**COUNTY OF SAN MATEO
PLANNING AND BUILDING DEPARTMENT**

DATE: December 14, 2016

SUBJECT: ADDENDUM: Consideration of a Design Review Permit, a Non-Conforming Use Permit, and a Certificate of Compliance (Type B), pursuant to Sections 6565.3 and 6137 of the San Mateo County Zoning Regulations and Section 7134.2 of the San Mateo County Subdivision Regulations, respectively, to allow construction of a new 2,278 sq. ft. single-family residence on a 3,500 sq. ft. non-conforming parcel. The Non-Conforming Use Permit is required to allow a 6-ft. front setback and a stairway landing front setback of one ft. (where 20 ft. is the minimum), a height of 33 feet (where 28 feet is the maximum), and to allow lot coverage of 35% (where 25% is the maximum) for the proposed house. Six significant trees are proposed to be removed. This item is continued from the October 26, 2016 meeting.

County File Number: PLN 2016-00051 (Katajamaki)

WEST AND EAST
 ELEVATIONS
A200

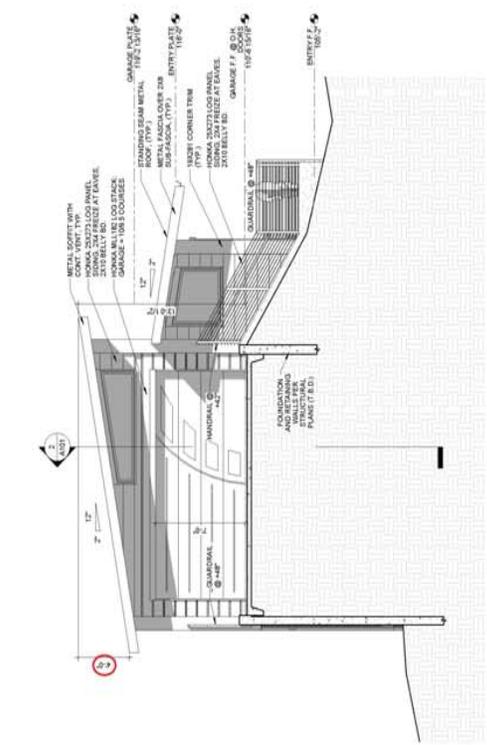
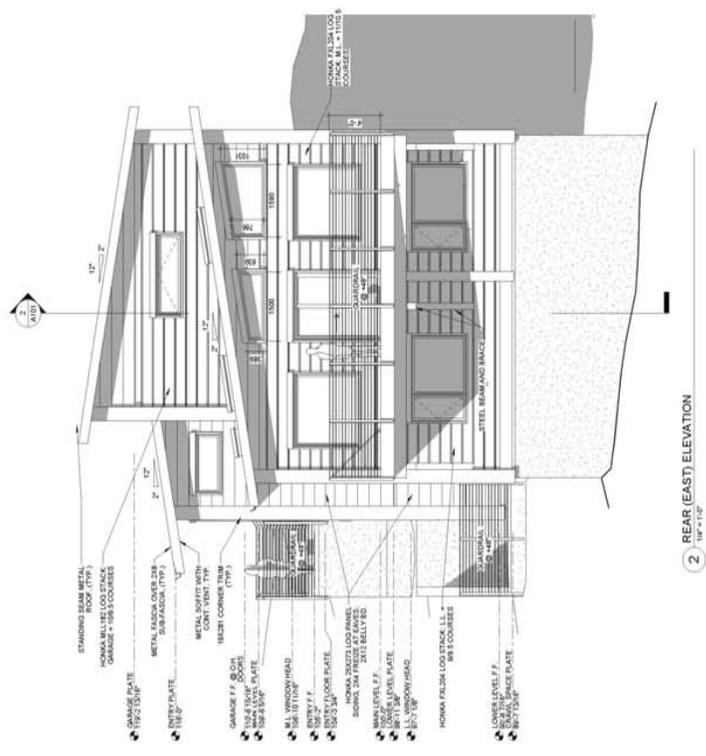
Design Review - Garage Facade

The revised proposal includes a new garage door style which was changed from a standard design to one with an asymmetrical window pattern. A window was added over the garage door and the roof was given an asymmetrical pitch to provide additional visual interest to the street level façade. The angle of the roof has been lowered on one side and the overall height of this facade varies over the width of the garage by approximately four feet. The window pattern on the garage door, additional window over the door, and the asymmetrical roof offer more visual elements on this elevation of the residence. The proposed color and materials did not change. The Emerald Lake Hills Design Review Officer has reviewed the revised project and has determined that it is consistent with the Emerald Lake Hills design review standards.

1 TREE PLAN
1" = 10'

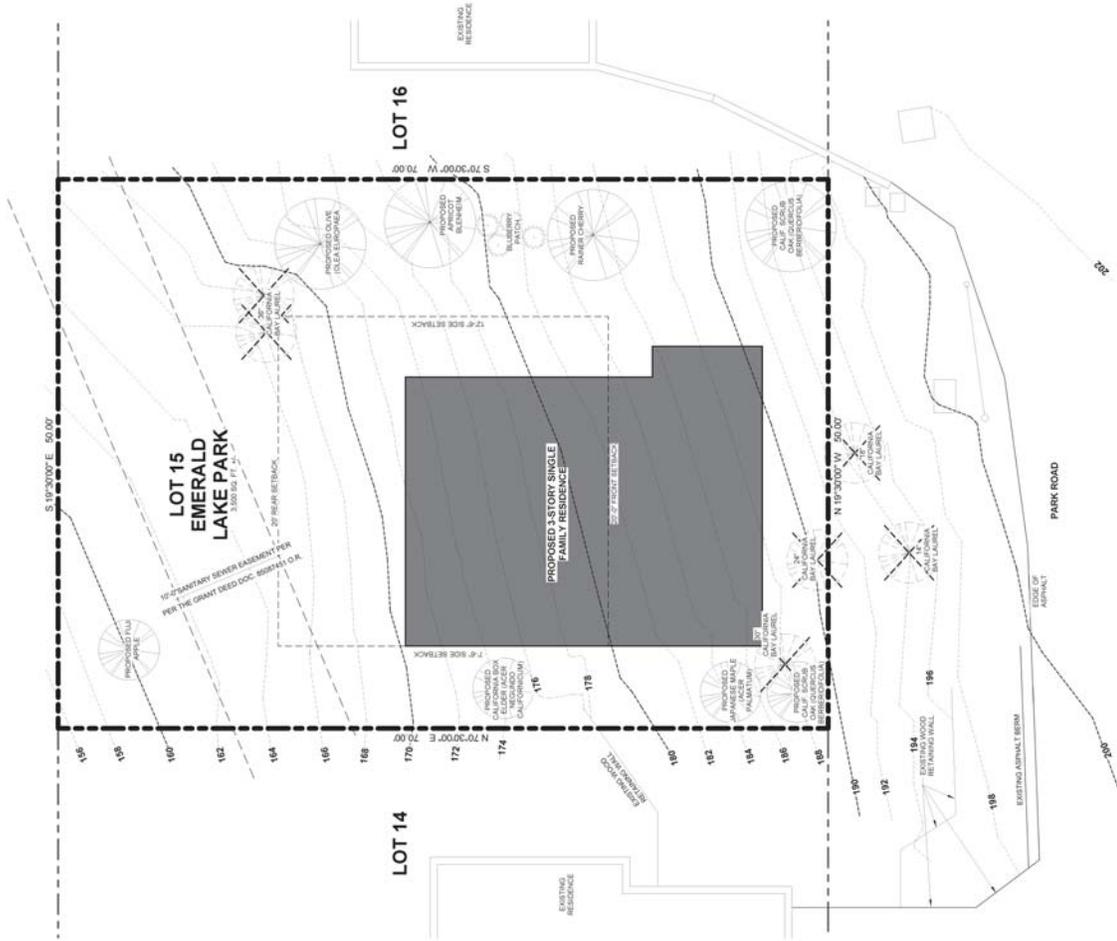
The applicant proposed birch trees to replace the six bay laurel trees which are to be removed to construct the proposed residence. The Planning Commission stated that these trees were not drought tolerant and may not survive to provide the desired privacy screening.

The applicant has revised the species of replacement trees from birch to an assortment of replacement trees as listed below. The required replacement trees have been reviewed by staff and have drought resistant qualities.

4. Six, 15-gallon size (minimum) replacement trees shall be planted as presented on the tree plan reviewed by the Planning Commission on December 14, 2016. Three of the six replacement trees shall be planted along the left side of the property, and the remaining three trees shall be planted between the right rear corner of the house and the property line.
